Re: PUCO Case No. 17-1509-RR-FED- In the Matter of a Request for the Installation of Active Warning Devices at the Akron Barberton Cluster Railway Grade Crossing on Seville Road (DOT#265-074A) in Medina County, Wadsworth, Ohio.

TO: Randall Schumacher, Supervisor, Rail Division, PUCO
FROM: Cathy Stout, Manager, Safety Section, ORDC
BY: Eric Neff, Safety Manager, Safety Section, ORDC
SUBJECT: Medina County Seville Road DOT 265074A (ABC) PID 104307
DATE: June 22, 2017

RE: Medina County Seville Road DOT 265074A (ABC) PID 104307

Diagnostic Review Team Survey

Field Sketch

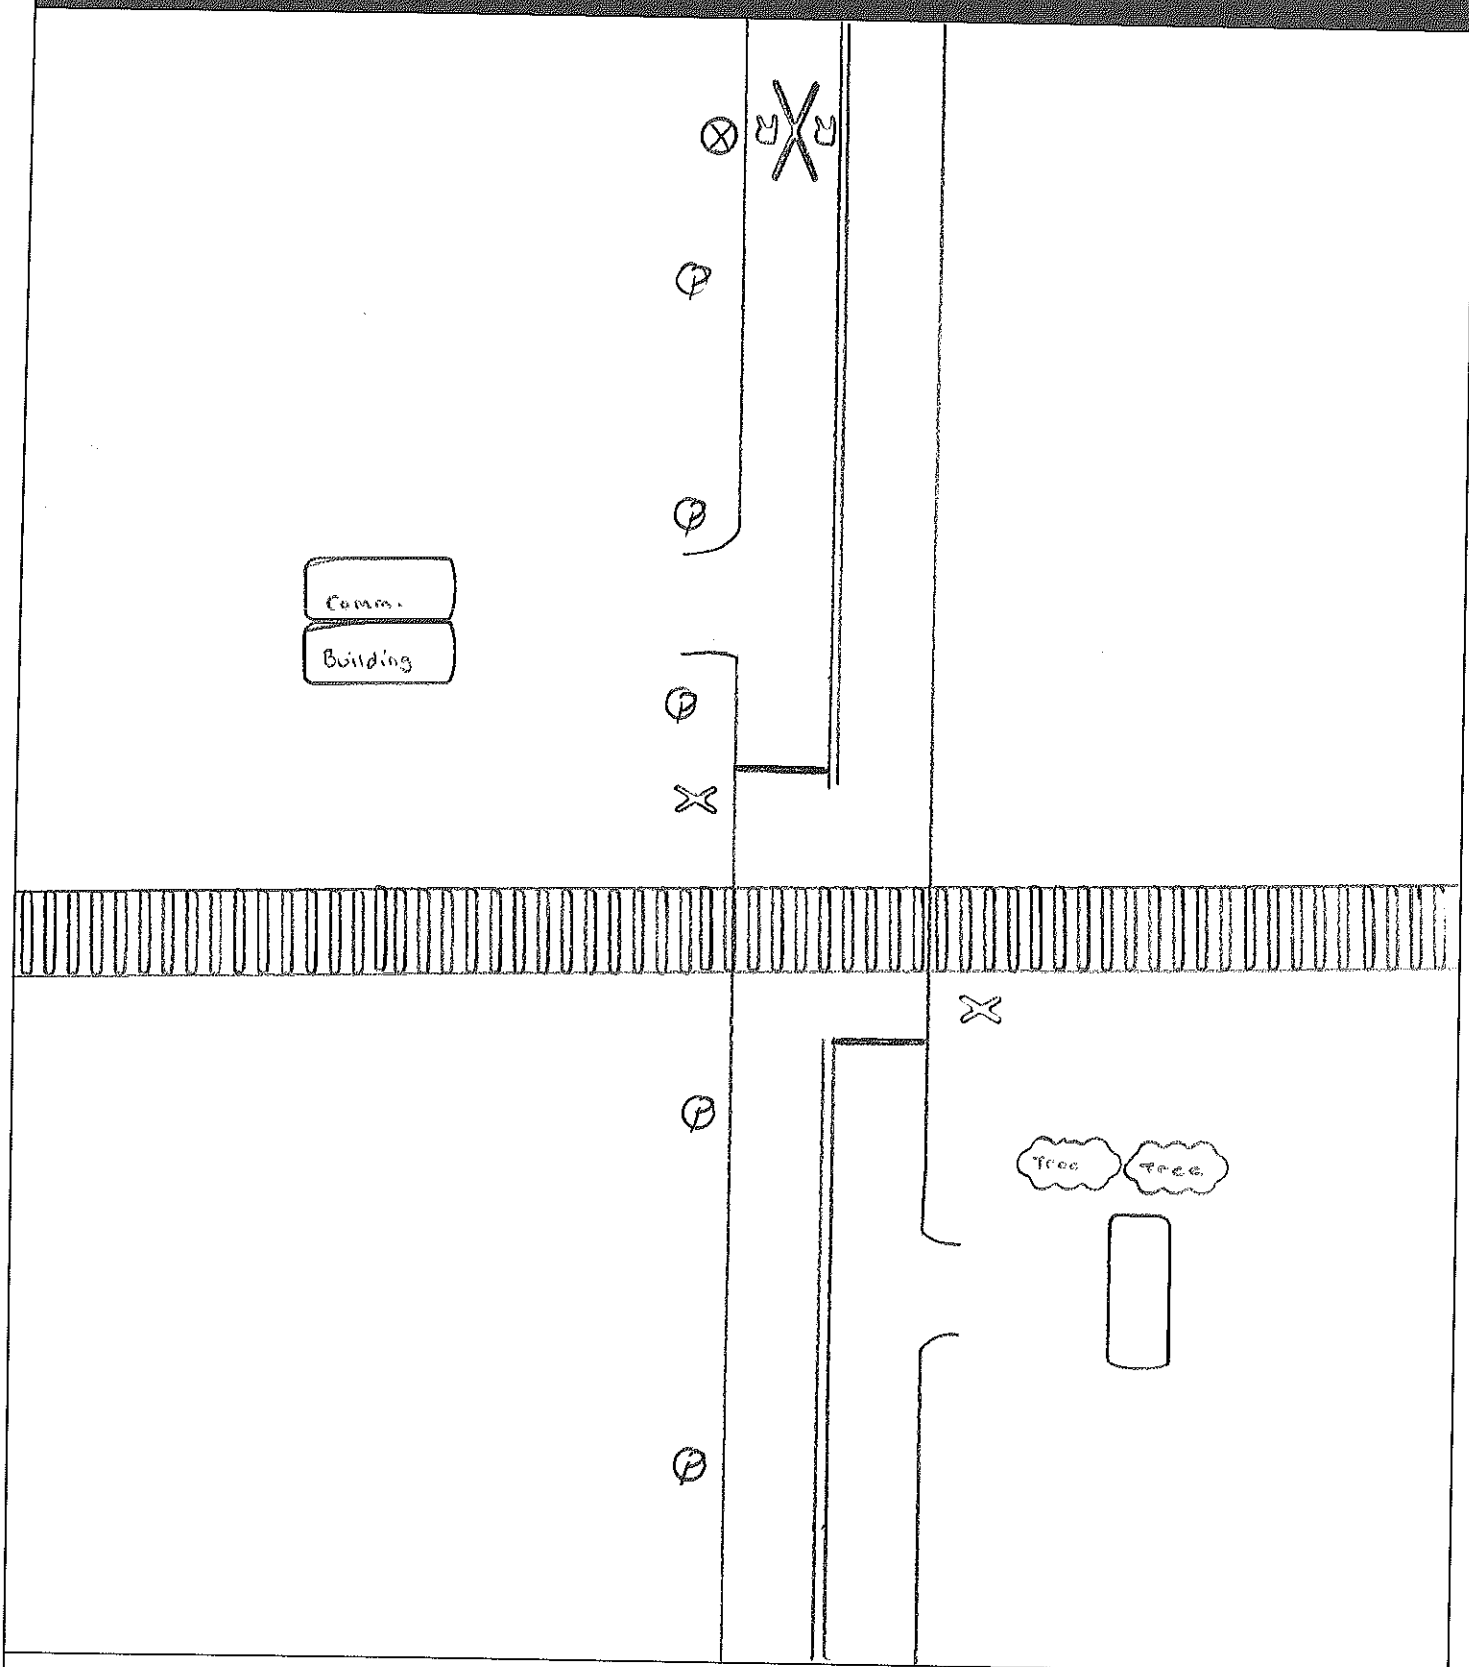
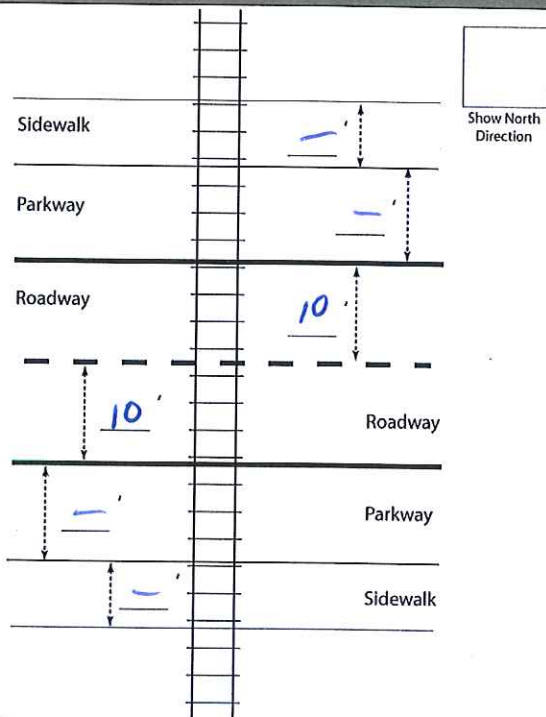
- ☒ Install/upgrade active devices
- ☐ Automatic Flashing Lights (AFLS)
- ☐ AFLS / Cants
- ☒ AFLS / Gates
- ☒ AFLS / Gates / Cants
- ☒ Bells / number
- ☐ Upgrade circuitry / type
- ☐ Sidelights
- ☐ Guardrail Needed
- ☐ Install/Replace curb
- ☒ Bungalow placement & offset from rail & highway
- ☐ Other (define)

SW Quad CANT Location
1 Bell

Eric T. Neff,
Upon review of the Seville Road Crossing it was found that while approaching from the north and traveling south there is a visibility distance of 2100 feet. Upon initial inspection it was suggested that this approaches visibility be improved with the use of a cantilever. After several visits and surveys of the traffic patterns at this crossing, I feel that the visibility distance is adequate and a cantilever is an unnecessary additional expense to this crossing project. That said, I request that it be removed from the consideration of the overall project. Thank you for your time and consideration of this request, I look forward to working with you on this and other projects in the future.

2/10/17 per emails dated 2/7/17 & 2/8/17 (in file) Cants are not need for project.

I agree with leaving out the cantilever.

I looked over the ABC's recommendation and I see no issue of dropping the cantilever.
